## **U.S. Environmental Protection Agency, August 20, 2008**

**USEPA-1.** Thank you for your review of and comments on the Draft SEIS. Responses to your specific concerns about air quality, environmental justice, and aquatic and biological resources are provided in response to comments USEPA-2 through USEPA-5 and USEPA-7 through USEPA-25 below.

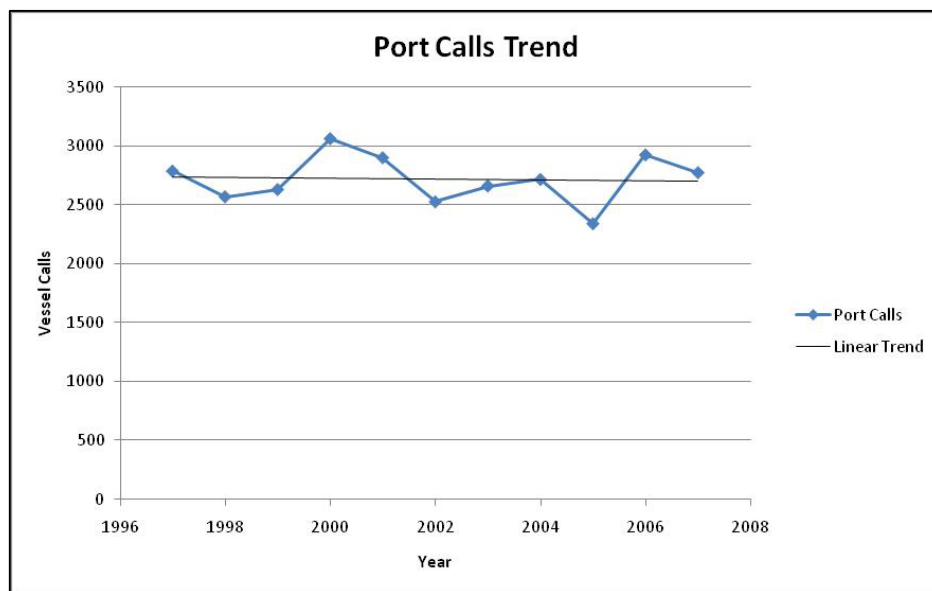
- CSLC-52.** The oil spill analysis focused on an evaluation of oil spill detection and response. The analysis also evaluated oil spills from ships, pipelines and crude oil storage tanks. While in port and offloading, a boom system will be deployed around the ship, thus making the response time a moot point. Before the start of cargo discharge operations, the vessel would be completely encircled by a spill containment boom. Spills from ships will be immediately contained. Unloading activities will be monitored using an automated Supervisory Control and Data Acquisition (SCADA) system which will monitor process parameters (e.g., oil flow, pipeline pressure, line balance, etc.) and shut down the pipeline if unexpected deviations in pipeline operating conditions are encountered. Thus, the system is effective in detecting oil spills regardless of the time of day. In addition, the marine terminal will be well lit and all activities monitored by facility operators, which can also aid in oil spill detection. If oil should be observed on the water within the vessel containment boom, all operations would be stopped and the facility's Oil Spill Response Plan (OSRP), which would have already been approved by the USCG, California

As noted in Chapter 2 of the Draft SEIS/SEIR, the Berth 408 Terminal will include an Oil Spill Containment System, which will include a spill boom launch boat, spill boom reels, remote spill recovery boom storage and launch facilities, and concrete-curbed platforms and equipment foundations. The facility is currently designed to accommodate 4,000 feet (1,219 m) of spill boom storage at the Berth 408 Terminal.

The Berth 408 Terminal would also be part of the Marine Spill Response Corporation (MSRC) cooperative which has large oil spill response assets distributed throughout San Pedro Bay, as shown in Table 3.12-3 of the Draft SEIS/SEIR. Currently, MSRC maintains 94,452 feet (28,789 m) of oil spill containment booms in San Pedro Bay. MSRC also maintains a wide array of response vessels and skimmers.

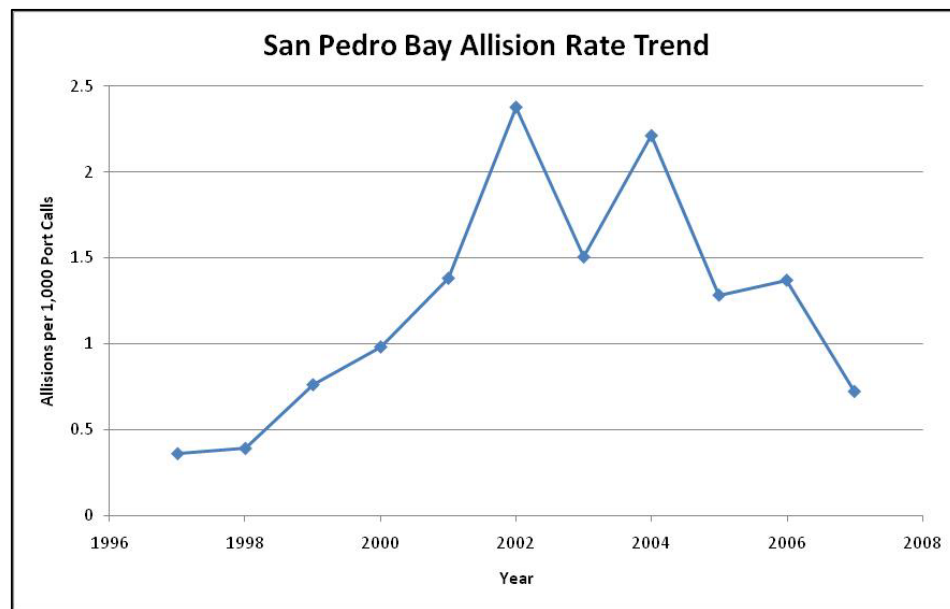
Regarding the issue of increasing cargo volume and increases in the number of TEUs per ship, the Port has evaluated current and future trends in cargo movement for San Pedro Bay (Mercer Transportation Group 2005). In this study, the historical and future trends clearly show an increase in TEU volume, with an accompanying decrease in cargo ship port calls.

A 2007 study conducted by the Port found that: “The average number of TEUs (twenty-foot equivalent units) per ship increased from 3,272 in 2001 to 5,260 in 2005, which reflects the 44-percent increase in container volume (a 61-percent increase in TEU densification per ship call), while overall containership calls fell from 1,584 in 2001 to 1,423 in 2005.” The text on Page 3.9-4, line 41 should have stated 1,423 container ships instead of 2,341 for 2005. This value will be corrected to avoid any future confusion.
